UNITED STATES PATENT AND TRADEMARK OFFICE

APPLICATION NO.	FILING DATE	FIRST NAMED INVENTOR	ATTORNEY DOCKET NO.	CONFIRMATION NO.
10/607,129	06/27/2003	Toshitaka Iwago	116194	5569
25944	7590	08/11/2004	EXAMINER	
OLIFF & BERRIDGE, PLC P.O. BOX 19928 ALEXANDRIA, VA 22320			GHATT, DAVE A	
		ART UNIT		PAPER NUMBER
				2854

Office Action Summary	Application No.	Applicant(s)
	10/607,129	IWAGO ET AL.
Examiner	Art Unit	
Dave A Ghatt	2854

DETAILED ACTION

Examiner's Marked-up Version of Figure 5.

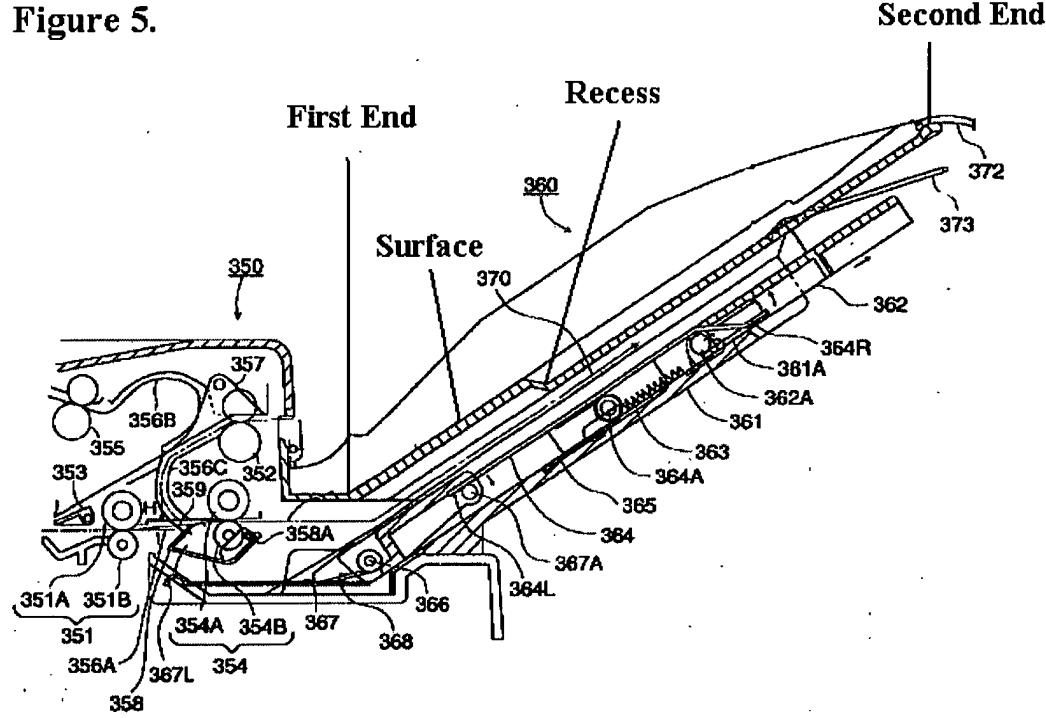
3. Claims 1-7 and 12-25 rejected under 35 U.S.C. 102(b) as being anticipated by Yoshie et al. (US 5,515,150). As outlined in the Abstract, and as illustrated in Figures 3-5, Yoshie et al. teaches the claimed method and apparatus. With respect to claims 1, 23, and 24, as illustrated below in the Examiner's Marked-up version of Figure 5 of Yoshie et al. teaches a tray 360, comprising a surface with a first end and a second end opposite to the first end. Figures 3 and 5 show a projection 372, which as illustrated in Figure 5 extends away from the surface and from the second end of the surface. As illustrated in the Examiner's Marked-up version of Figure 5, Yoshie et al. teaches a recess formed below the surface and from the projection 372 toward the first end.

With respect to claim 5, Figure 5 of Yoshie et al. shows the projection 372 extending from the surface such that the projection has a height that is higher than a

discharge point (shown generally at 374 in Figure 5) at which the documents are discharged from the feeding device.

With respect to claim 6, Figure 5 shows a distance between a discharge point (generally located at 374 in Figure 5) at which the documents are discharged from the feeding device and an end of the recess located on the first end side is shorter than a length of the documents discharged onto the surface. See column 11 lines 4-10.

With respect to claim 7, Figure 5 shows the distance between a discharge point (generally located at 374 in Figure 5) at which the documents are discharged from the feeding device and an end of the projection located on the first end side is not equal to a length of the documents discharged onto the surface. See column 11 lines 4-10.

With respect to claim 14, as shown in Figures 3, 5, and 6, the projection 372 is moveable from a first position (shown in Figures 3 and 6) with a bottom surface of the projection against the surface to a second position (shown in Figure 5) with the bottom surface inclined away from the surface.

With respect to claim 15, Figure 6 of Yoshie et al. shows the projection 372 in the recess. Figure 3 shows the structure of projection, illustrating a plurality of recesses for accommodating the projection. Therefore, this structure meets the requirement for a second recess formed under the projection such that when the projection is in the first position, abutting ends of the recess and the projection are on a same plane.

With respect to claim 16, Figure 6 shows the recess surrounding a part of the projection 372.

With respect to claim 17, Figures 5 and 6 illustrate the structure of the recess, which is not symmetrical.

With respect to claim 18, the teaching of Yoshie et al. meets the limitations of this claim. Figure 5 shows a width of the recess decreasing *with proximity to* the first end.

With respect to claim 20, as illustrated in Figure 5, a depth of the recess formed below the surface increases with proximity to the first end.
